**Re: State Significant Development Application Number SSD-66777221
2-8 Lanceley Place and 14 Campbell Street, Artarmon.**

ATTACHMENT 1

Architectural elevation showing carpark and civil levels below the existing natural level.

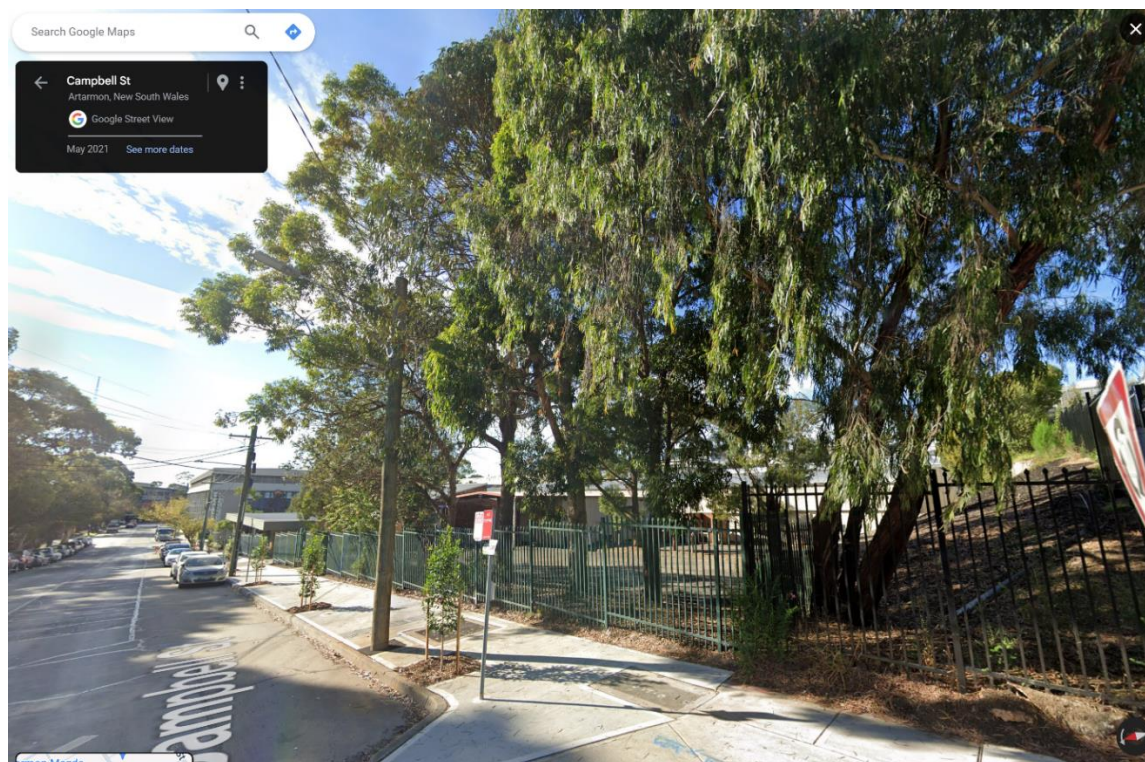
The elevation on the architectural plans shows the car park and civil levels to be lowered from the existing ground levels.

The plans do not show any retaining walls around the car park, which suggests it will be a sloped garden bed from the existing boundary levels down to the carpark level, however, the plans are unclear on this.

More detailed investigation of the root systems of trees 18-25 and some minor alterations to the design for the car park area and fence footings to maintain the existing carpark levels could allow for the retention of these established trees and should be investigated.

Google street view (image: May 2021) of existing trees along Campbell Street in NE corner of the site proposed for removal.

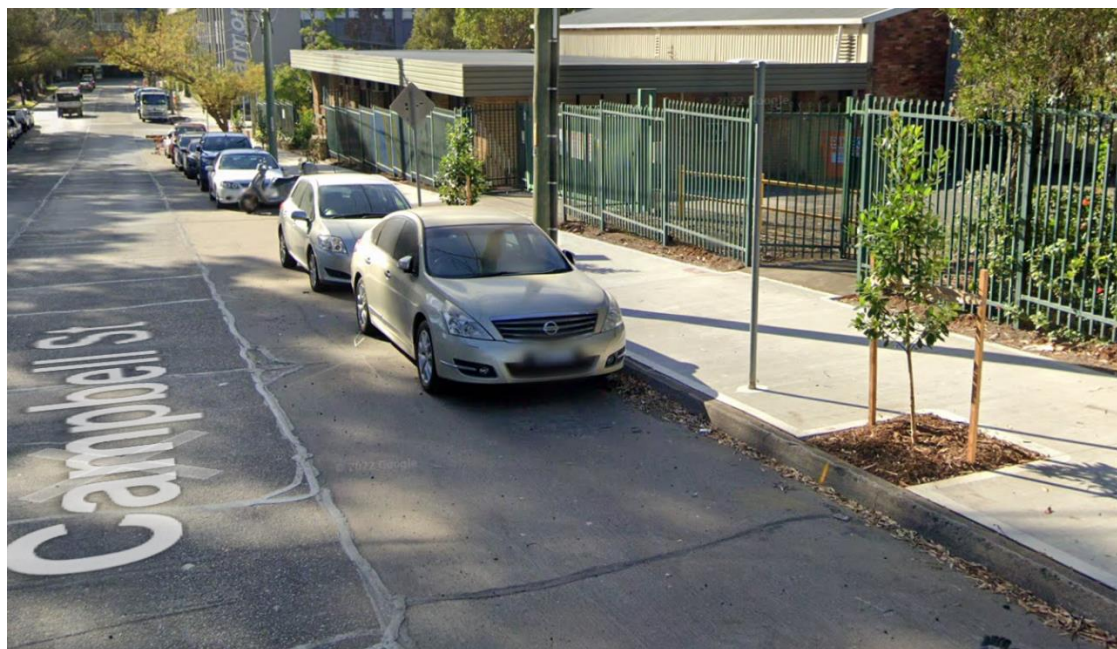
There are a number of mature established trees along the Campbell Street frontage (trees 18 - 25) proposed to be removed and replaced with a group of native trees in the same location. It was noted in Appendix I – Landscape Report that “due to security and operational constraints, all existing trees are proposed to be removed”. This was noted to

be due to the construction method of the proposed 3m high security fence requiring a continuous strip footing that will intersect the roots of these trees. The root zone encroachment for each tree has not been clearly shown on the plans or in the arborist's report and details of the fence and strip footing have not been provided. More detailed plans should be provided and this should be further interrogated as part of the assessment. Options for retention of these trees should be considered.

Landscape Plan of front entrance to the building.

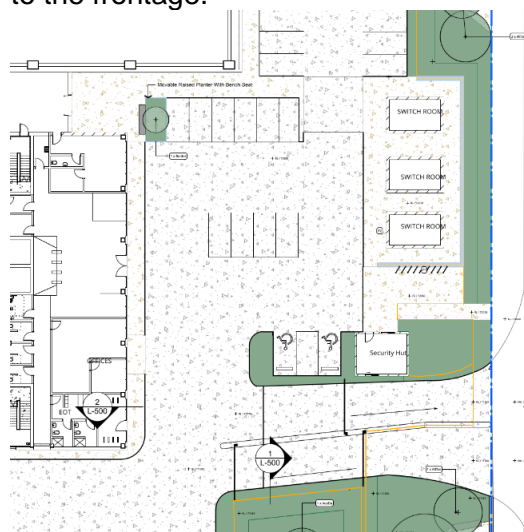
Whilst the landscaping appears to address the streetscape area frontages, there is a lack of landscape and planting around the entrance and car park area, with the only planting near the building entrance being a "movable planter".

Additional tree planting to provide some canopy shading to the car park areas will assist in reducing urban heat, as well as additional softening of the built form and paving expanse to the frontage.
